# Montgomery County Historic Preservation

## Staff Report

<p><b>ADDRESS:</b> 23351 Davis Mill Road, Germantown</p> <p><b>RESOURCE:</b> Cedar Grove Historic District</p> <p><b>APPLICANT:</b> Alexander Chester</p> <p><b>REVIEW:</b> HAWP</p> <p><b>CASE NO.:</b> 1145858</p> <p><b>PROPOSAL:</b> Tree removal, demolition of existing garage, and construction of new garage</p>	<p><b>MEETING DATE:</b> 5/27/2026</p> <p><b>REPORT DATE:</b> 5/20/2026</p> <p><b>PUBLIC NOTICE:</b> 5/13/2026</p> <p><b>TAX CREDIT ELIGIBLE:</b> No</p> <p><b>STAFF:</b> Laura DiPasquale</p>
--	---

Figure 3: Left, site plan showing the existing garage to be demolished and proposed new garage. Right, site plan showing existing trees and proposed trees to be removed and the additional proposed gravel driveway width.

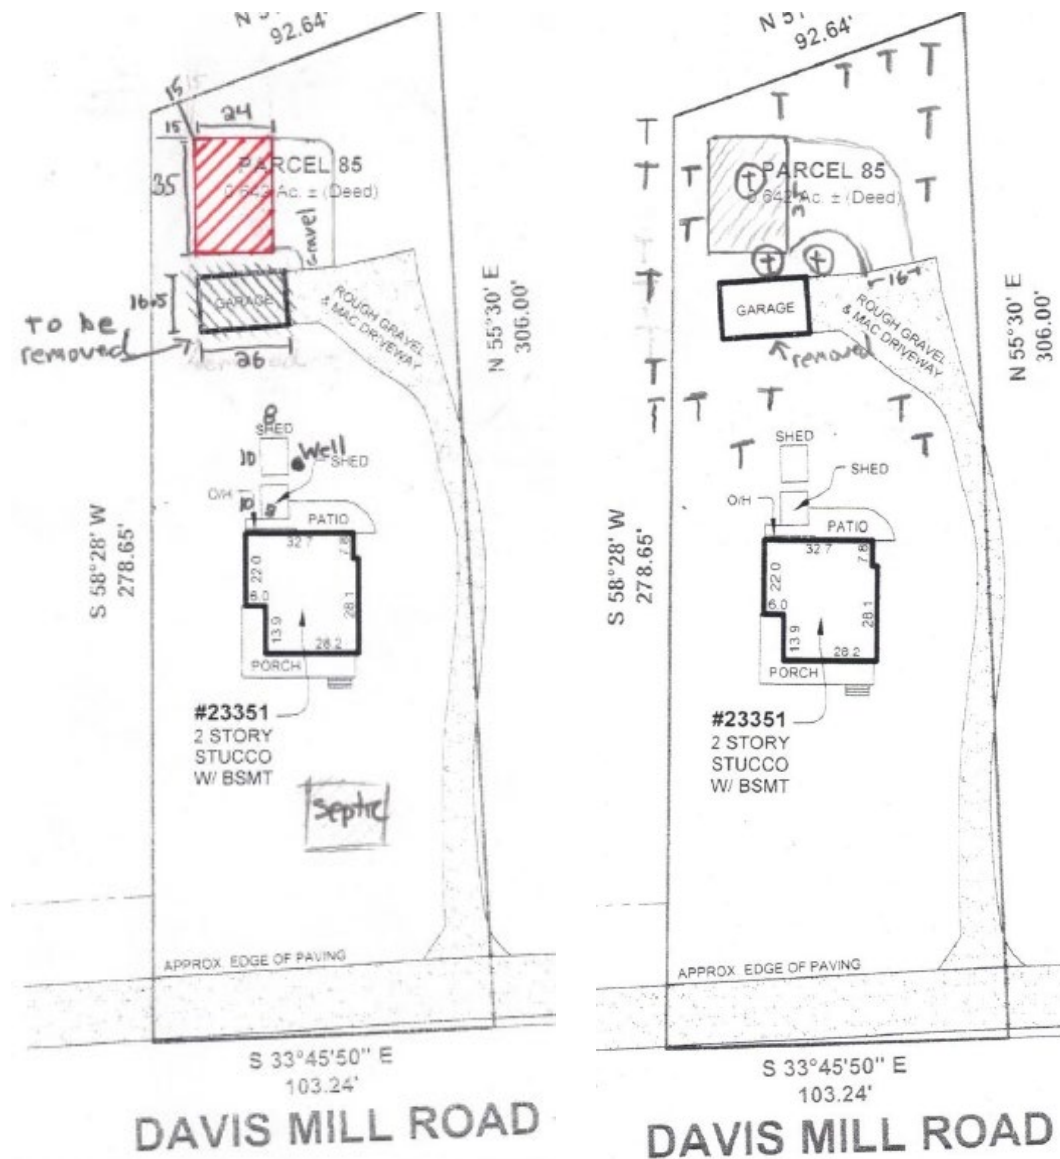
Staff concurs with the HPC's previous assessments that the removal of the existing garage leaves fully intact the Contributing resource and its demolition would not substantially alter the exterior features of the resource, per Chapter 24A-8(b)(1), (d), and the historic character of the property would be retained and preserved per *Standard 2*. Likewise, staff finds that the removal of select trees at the rear of the property will not have a significant impact on the property, per Chapter 24A-8(b)(1).

1. The applicant must submit final dimensions for the new gravel driveway and parking pad, which must not exceed 1,100 square feet.
2. The proposed structure may decrease in size to any dimension smaller than 24-ft by 35-ft within the proposed footprint.

Figure 4: Renderings of the proposed garage presented at the February 25<sup>th</sup> HPC meeting.

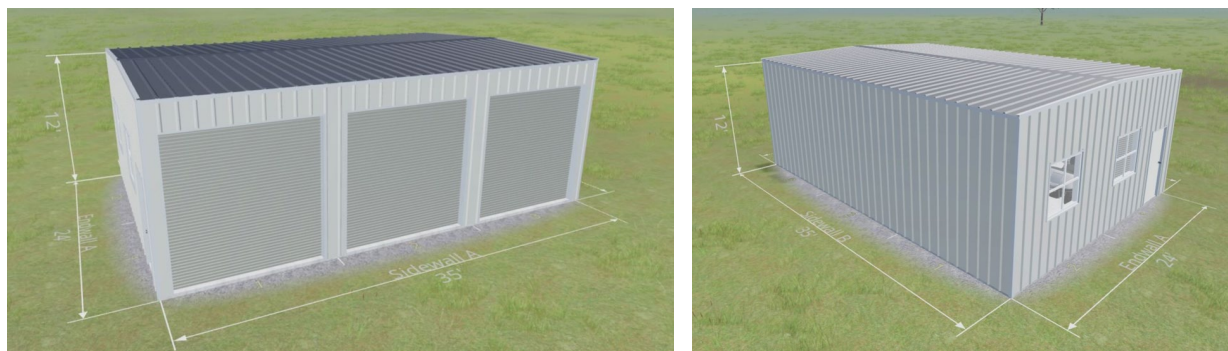
The HPC held a preliminary consultation review for the proposed project at its February 25, 2026 meeting. At that meeting, the HPC offered the following comments:

- Increasing the pitch of the gable roof, adding corner boards, and differentiating the roofing from the siding of the proposed garage would create more traditional proportions, massing, and design, making the structure more compatible with the district, per Chapter 24A-(b)(2).

Following the HPC feedback at the preliminary consultation review, the applicant has revised the design to increase the roof pitch and overhang, differentiate the siding and roofing materials, and add corner boards. By increasing the roof pitch, the revised design also increases the overall height of the proposed roof peak to 16 feet, while the eave height remains 12 feet as previously proposed. The applicant has also revised the tree removal proposal to remove three trees as opposed to five as originally proposed.

Figure 5: Renderings of the proposed garage.

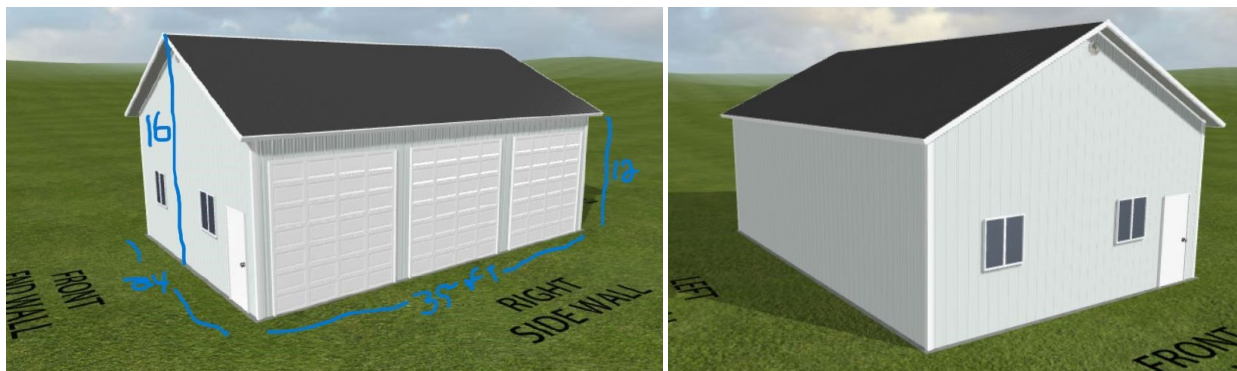
Staff finds that the revised design complies with the HPC feedback, and that the proposed design is compatible with the district and resource, per Chapter 24A-(b)(2). Staff finds that, although the footprint of the proposed structure is large, at approximately 80 feet from the rear of the main block and at 1-story in height, the proposed structure is appropriately scaled and located far enough away from the 2.5-story historic building to maintain its character and that of the site and setting, per *Standard 2* and Chapter 24A-8(b)(1).<sup>1</sup> Staff further finds that owing to its placement at the far rear of the property, if the garage were to be removed in the future, the integrity of the historic resource would remain, per *Standard 10*.

With a footprint of 840 sq ft to the main house's approximately 1,174 sq ft footprint, the proposed structure exceeds the footprint allowable by Zoning in the AR zone, which specifies that the cumulative footprint of all accessory buildings on a lot with a detached house may not exceed 50% of the footprint of the principal building, unless the structure is for agricultural use. The property has two other smaller sheds whose square footage has not been identified. Following HPC approval, the applicant has indicated that they wish to seek a Zoning variance for the size of the structure. As such, staff notes that additional revisions to the size of the structure might be required. Staff also notes that the submitted site plan does not fully dimension the proposed gravel area, which appears to be approximately 35-ft by 30-ft, and recommends that the HPC condition approval upon submission of the final site plan details, with additional gravel paving not to exceed 1100 square feet, and delegate approval authority to staff for a revised garage of any size smaller than the proposed garage within the existing proposed footprint.
